Ivanhoe Estate Redevelopment Concept – development application (SSD 8707)

CITY OF RYDE INITIAL SUBMISSION

IVANHOE ESTATE REDEVELOPMENT CONCEPT STATE SIGNIFICANT DEVELOPMENT (SSD 8707)

Figure 1. Plan showing the required road connection to Peach Tree Road.

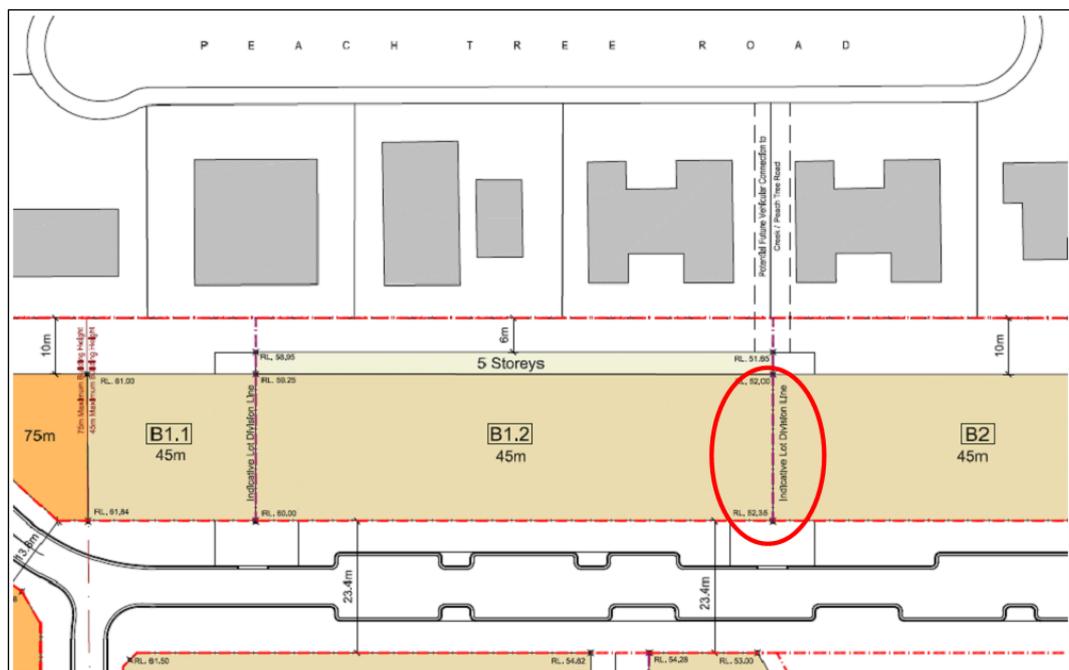
- f. **Road Connection:** Future road for connection to Peach Tree Road on the northern side of the site has not been shown on the Master Plan. Although this road is not shown in the Access Network in Part 4.5 of Ryde DCP 2014, a future road connection has been discussed with the applicant. Such a road will increase the permeability throughout this area. Council seeks that a clear gap be provided between Building B2 and B1.2 to enable road connectivity to Peach Tree Road as demonstrated in Figure 1. This gap will need to accommodate a 14.5m wide road as well as the appropriate setback.

Figure 2. Plan showing the building setbacks to various streets.

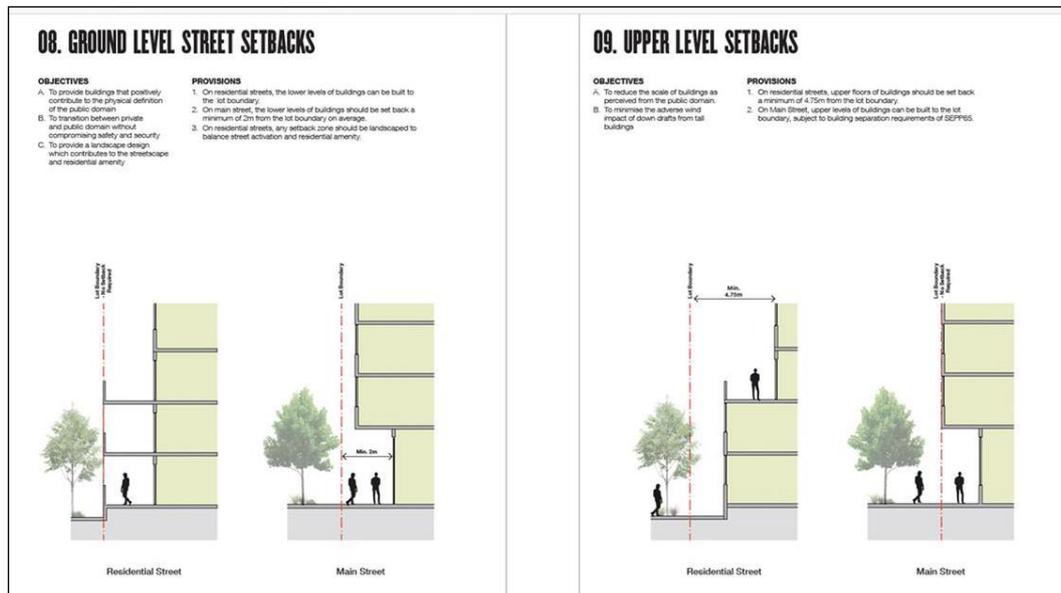
Council has concerns regarding the proposed building setbacks from the proposed new roads as it seems that the high rise buildings will be built to boundary as shown in the design guide submitted with the application. It seems that the application seeks to establish a street wall from ground level to the top most levels or provide an inadequate setback or reduced front setbacks of buildings without considering potential detrimental amenity, aesthetics and streetscape impacts.

The figures below shows the nature of building setbacks proposed from the various streets:

Figure 3. Plan showing the extent of the basement over whole site

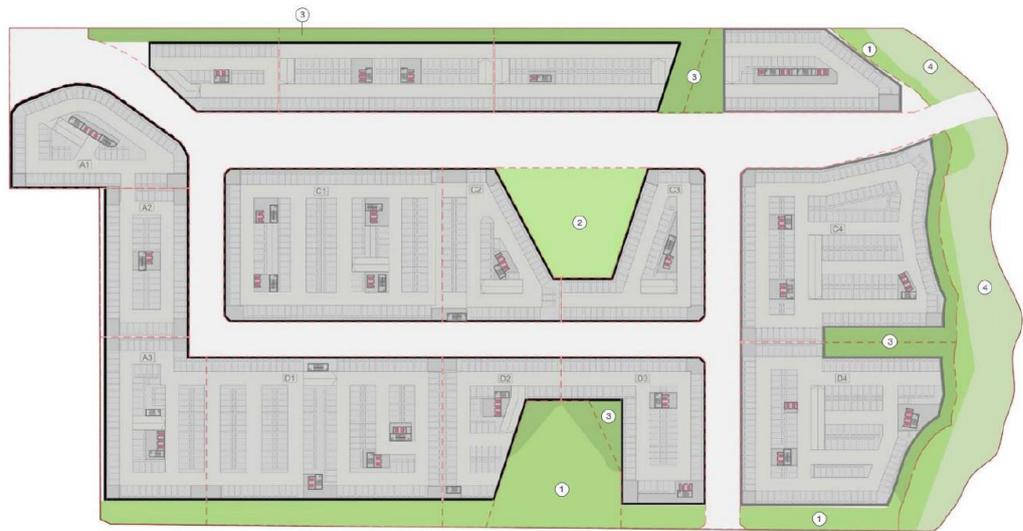
Concern is raised in relation to the extent of the building footprints and the lack of regard for the existing trees located to the periphery of the site. Extensive basement car parking is to result in the removal of a significant number of trees across the site due to excavations necessary for

construction. This is clearly demonstrated visually below whereby the extent of basement car parking is illustrated.

Figure 5. Aerial image with site outlined red indicating moderate-high canopy cover (Source: Google Map 2018)

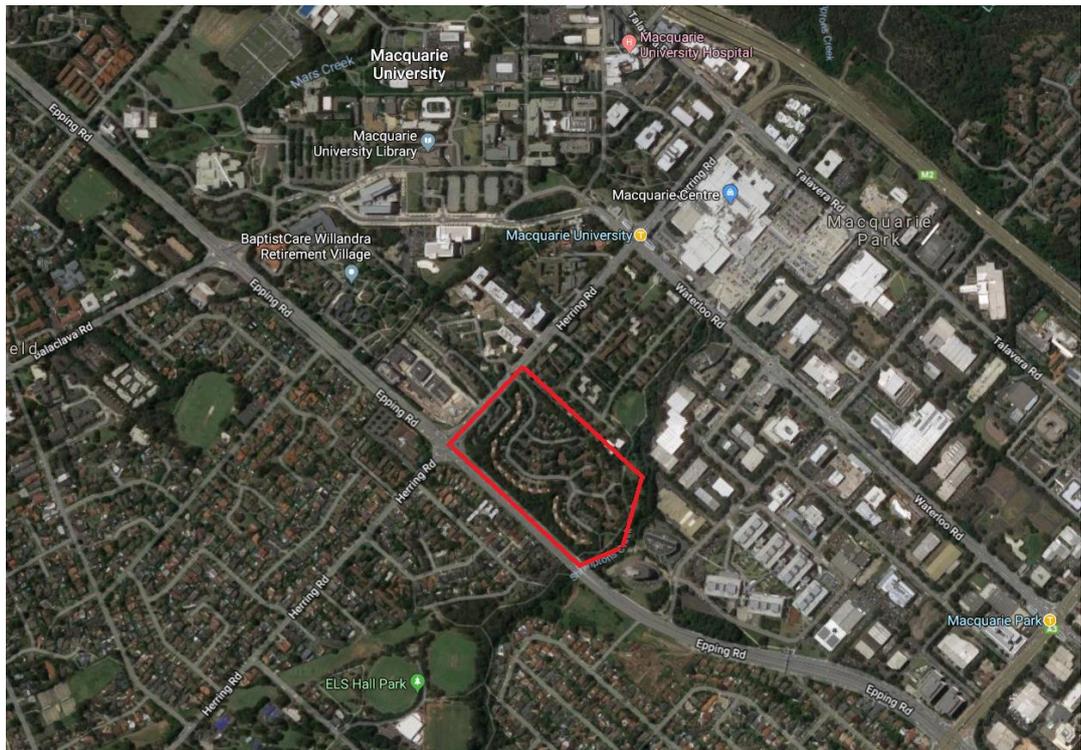
Given the overall impact to existing trees and the inability of the site to accommodate large tracts of deep soil planting or provide a 1:1 replacement planting ratio, the proposal is considered likely to have a negative impact to the landscape character of the site and locality. This will be particularly evident during the short-medium term following construction whereby existing mature vegetation will be replaced with juvenile trees of low visual prominence resulting in a high visual impact.

Figure 18 Macquarie Park travel to work mode share by place of enumeration

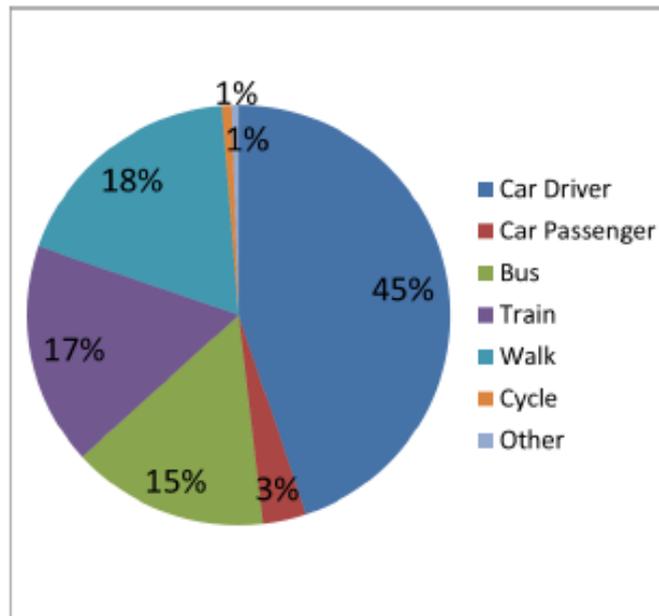
The applicant has compiled a Journey to Work (JTW) profile of the proposed development. This has been compared with the Macquarie Park Bus Priority and Capacity Improvements Program. Whilst it is noted that both reports are using the same JTW stats from 2011, the values are significantly different without adequate justification.
